BELL SYSTEM PRACTICES

ADDENDUM C32.535

Issue A, 10-15-53-N

500 TYPE TELEPHONE SETS

Figure 3

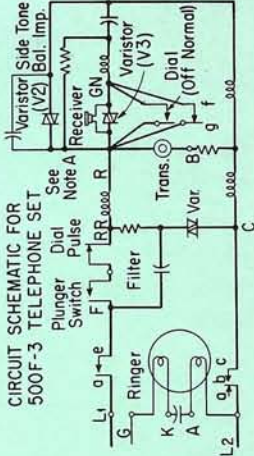
500E-3 & 500F-3 TELEPHONE SET

WIRING DIAGRAM

A. 500E-3 (For Manual Service) same as 500F-3 except replace dial with apparatus blank and strap terminal on plunger switch to (RR) terminal on network with black lead as shown.

B. When the handset is removed, contact, *gf*, breaks last.

Figure 4

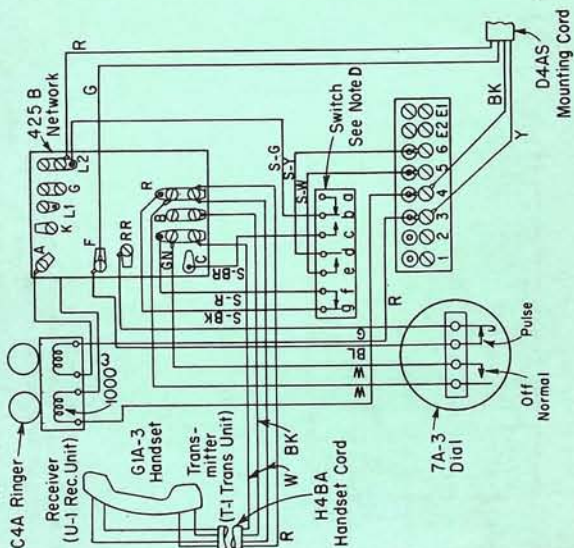
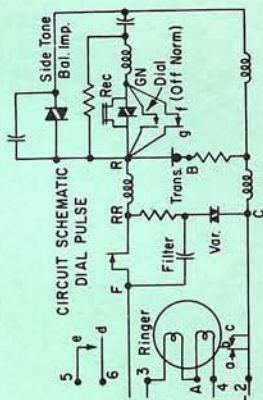
500 M-3 TELEPHONE SET

A. For manual service: (500 L-3) same as 500 M-3 except replace dial with apparatus blank and transfer green lead from (F) to (RR) terminal on network.

B. When ringer condenser is required in series with ringer, transfer slate ringer lead to (K) terminal on network.

C. Contact sequence:

Removing handset - l. de closes before cb

2. fg opens

Restoring handset- l. fg closes

2. cb opens before de
